ITEM NEED	PART NUMBER	DESCRIPTION		
TITLE NO. ADVANTAGE 385/395, 208-240V		AMERIGRAPH		
MANUAL		SIZE	DRAW. NO.	
FINISH		D	SHD.	DATE
MATERIALS, COATINGS, ETC.		ALL IN PICTURES ARE	DRAWING NUMBER	
PRICES, ETC.		NOT DRAWN	REV.	
PRINTS, ETC.		PRINTED	WD118-2	
THIS PRINT

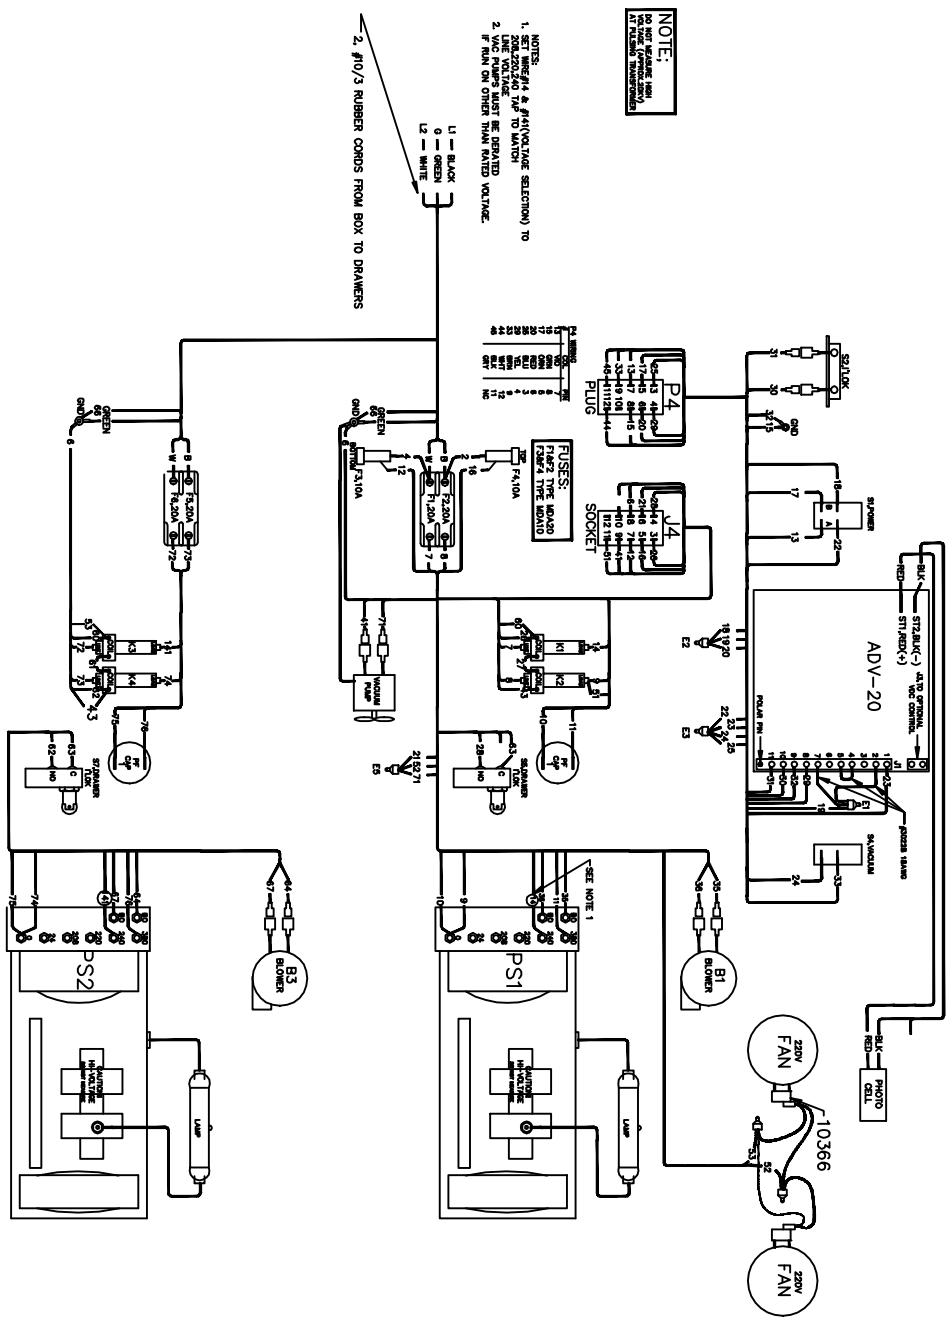
EFFECTIVE 6/06, CHANGED CKT SO THAT BOTH LITES TURN OFF IF EITHER DRAWER IS OPENED
